**Ordinance Number: 1365-23, File Number: 19-24**

**RTA Tunnel Membrane Replacement- Addendum 3**

**NARRATIVE:** Addendum 3 contains the following:

Project Title: RTA TUNNEL MEMBRANE REPLACEMENT			
Sheet Title: MAINTENANCE OF TRAFFIC - PHASE 2			
Designed: MSI	Drawn: MSI	Checked: LGW	Approved: LGW
Scale: AS SHOWN		Project No.: 198348	
Date: FEBRUARY 2024		Sheet: C-11

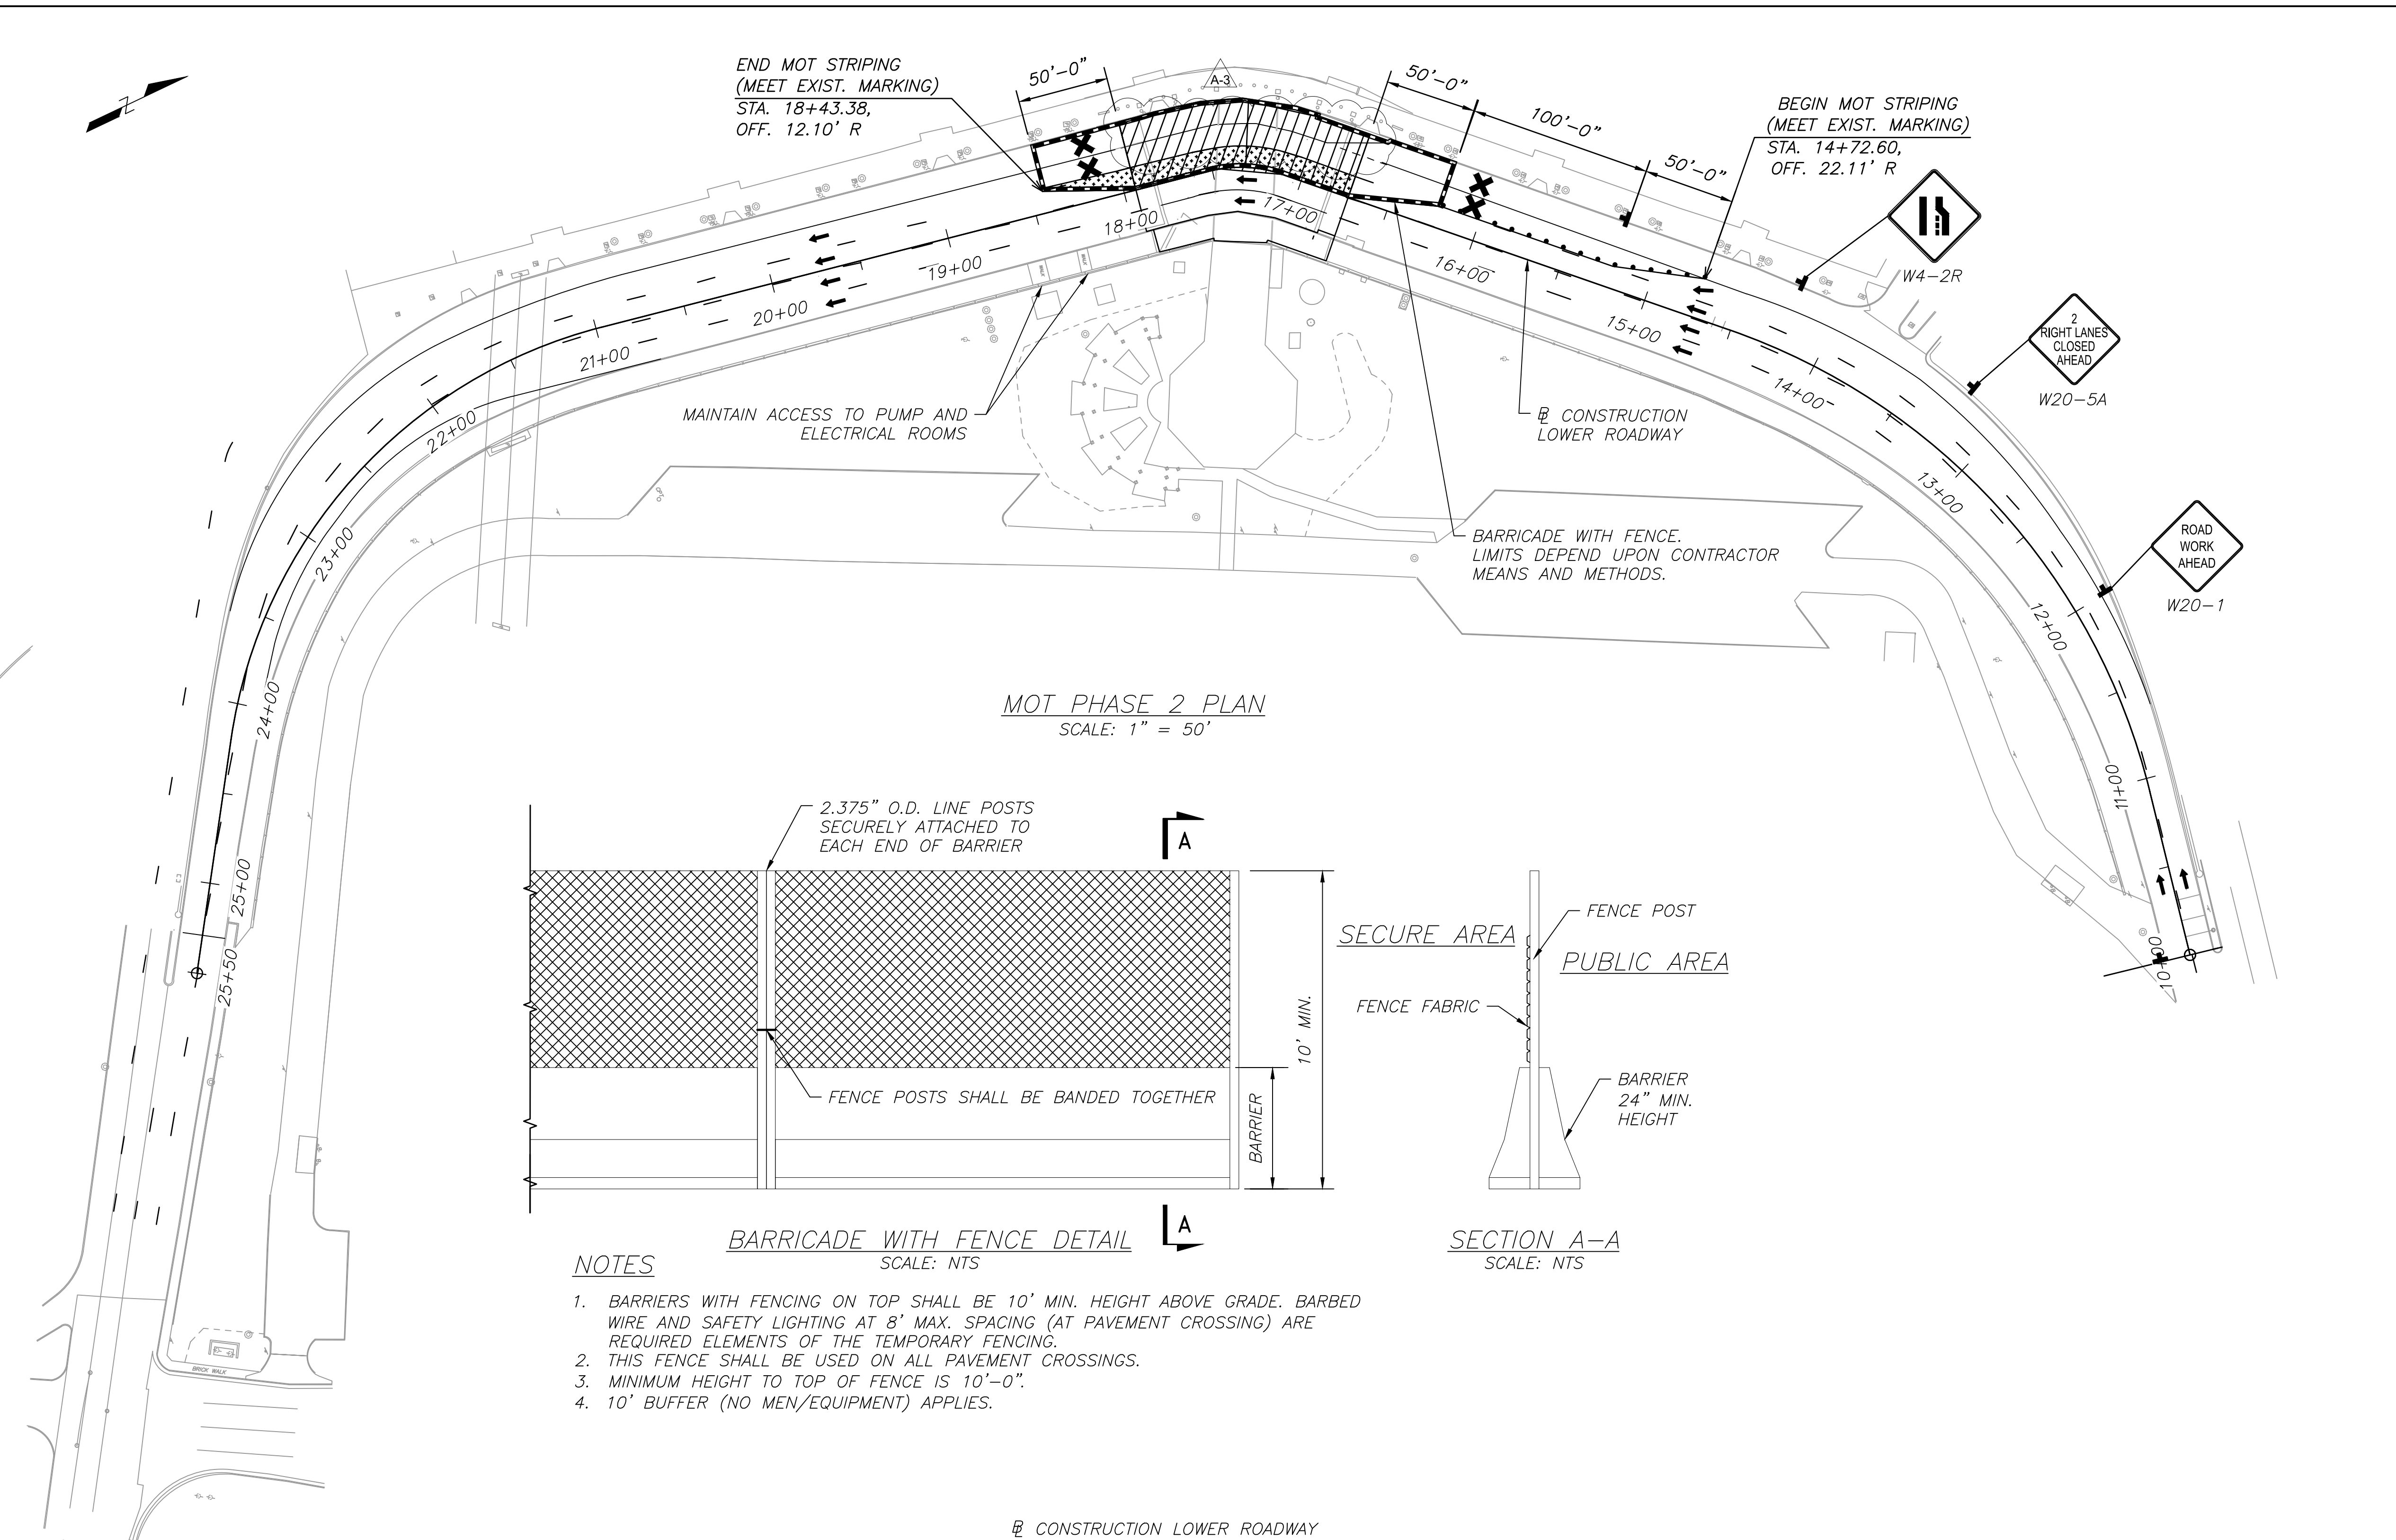
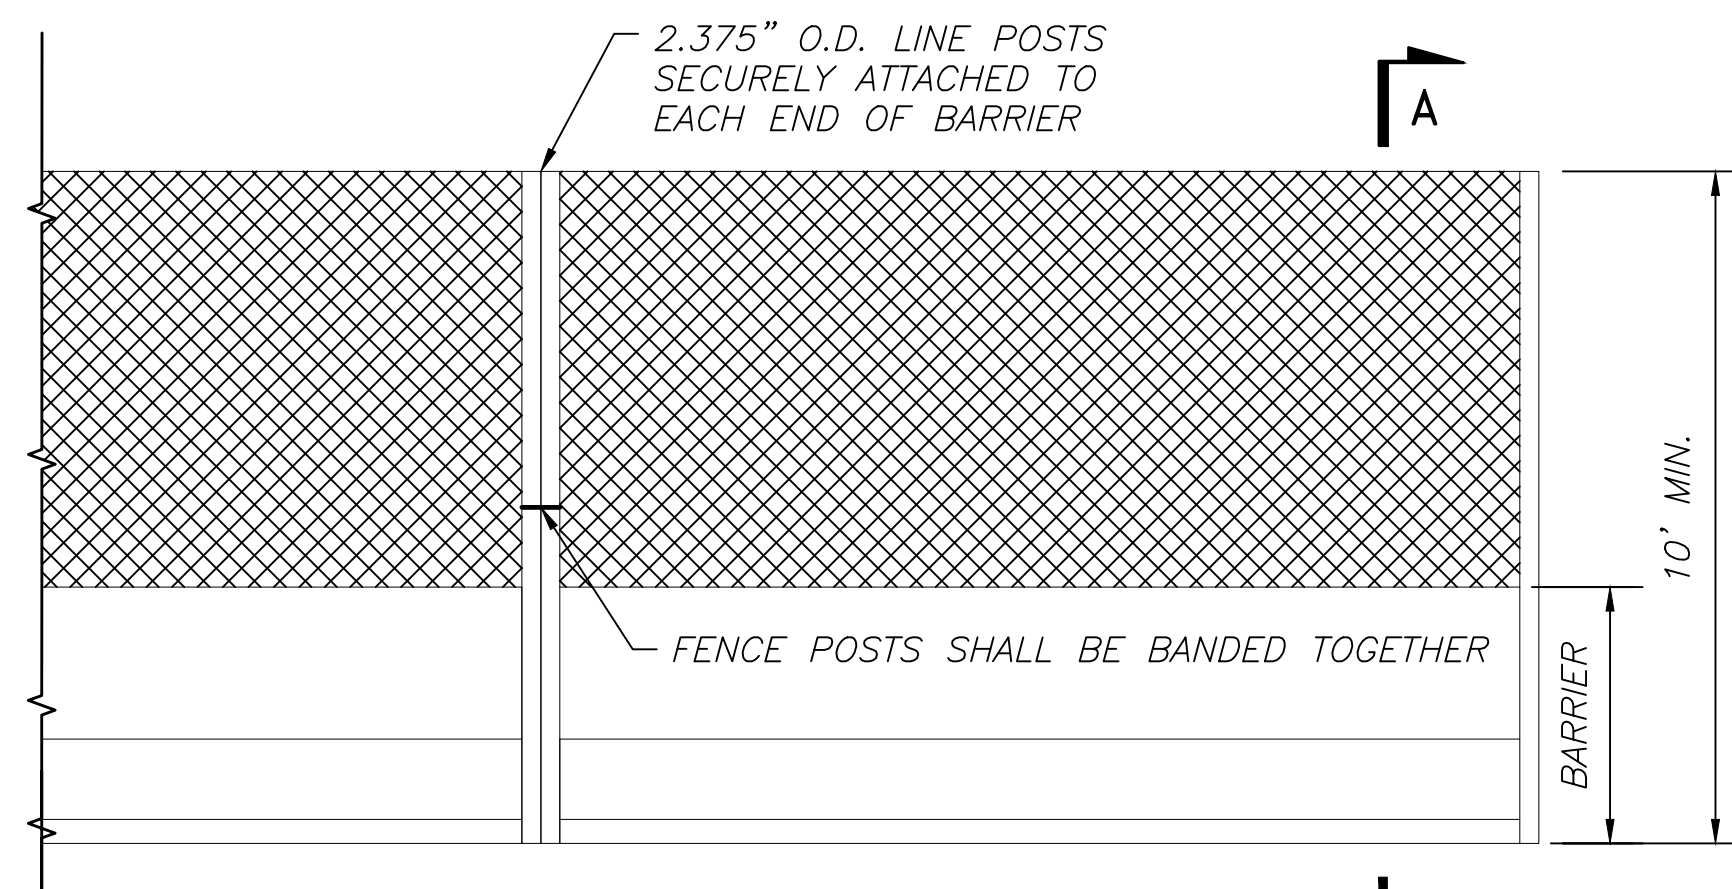
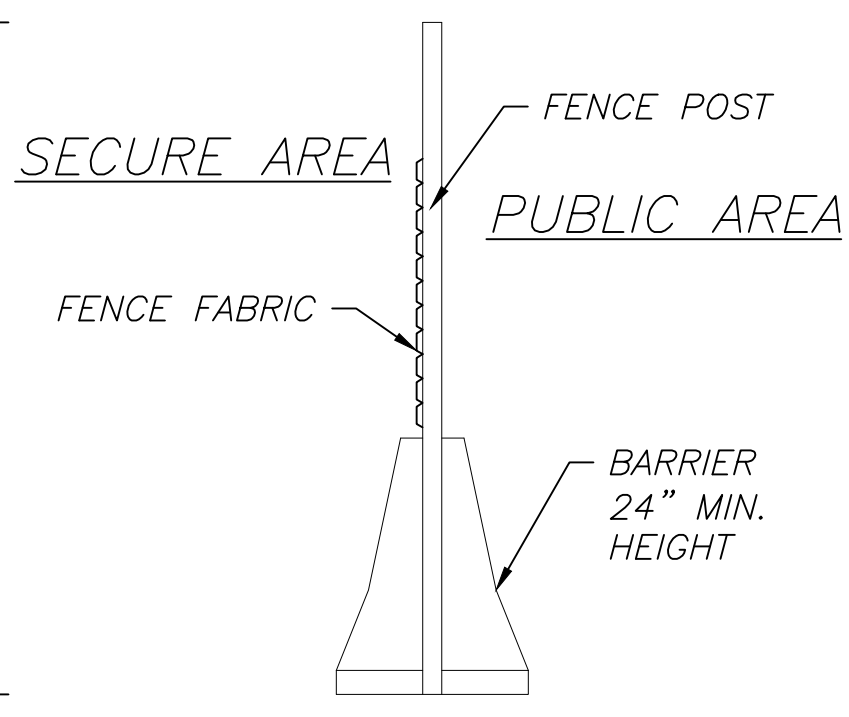
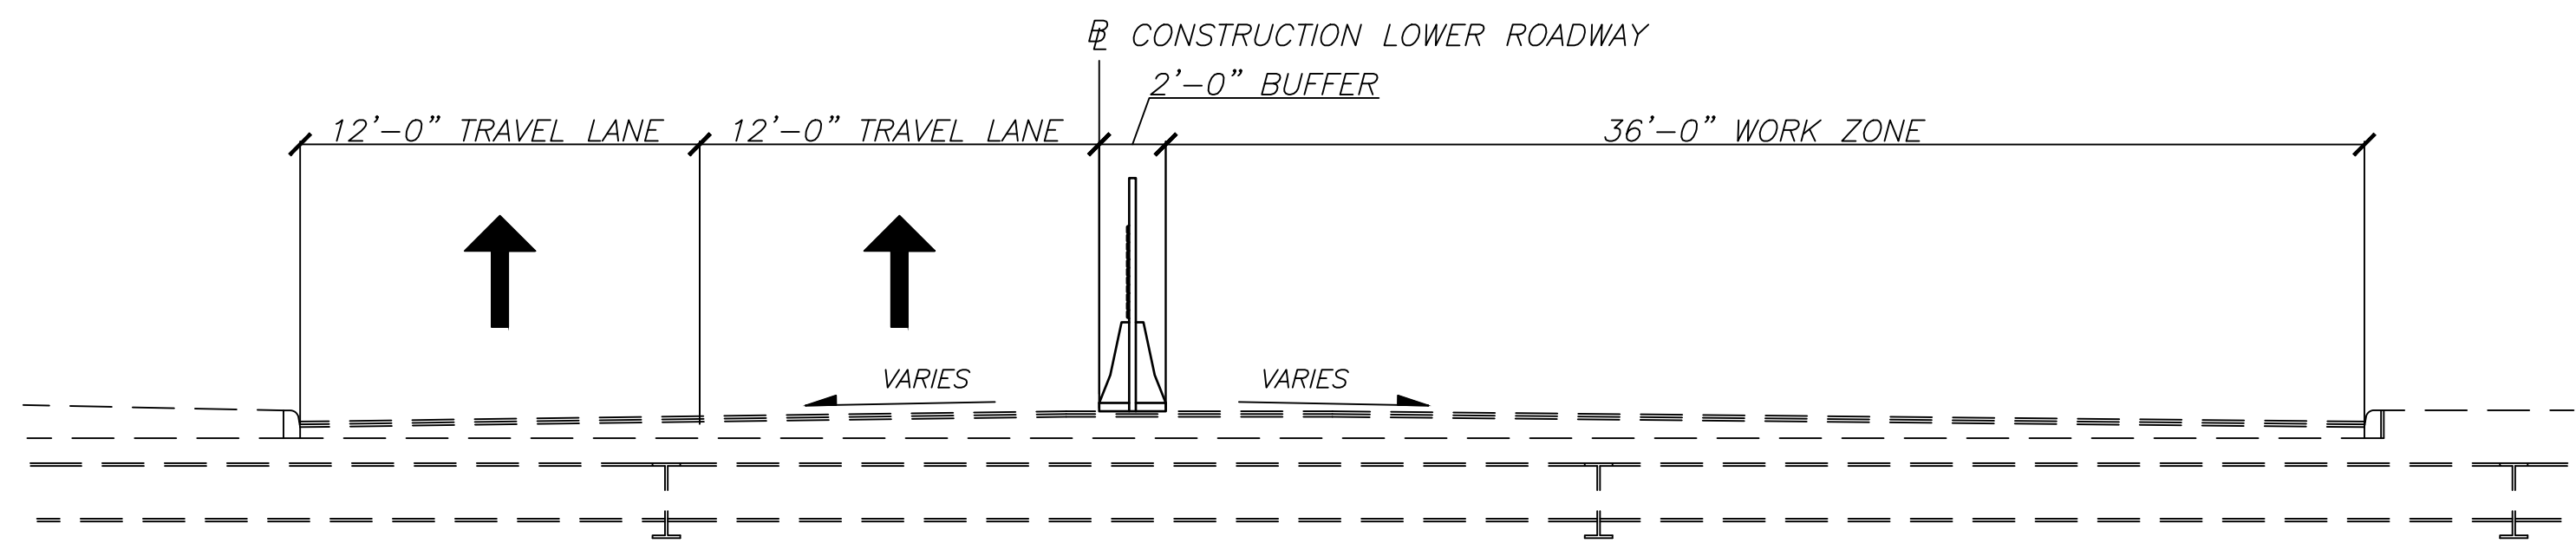
NOTE: ENTIRE SHEET REVISED FOR ADDENDUM A-3.
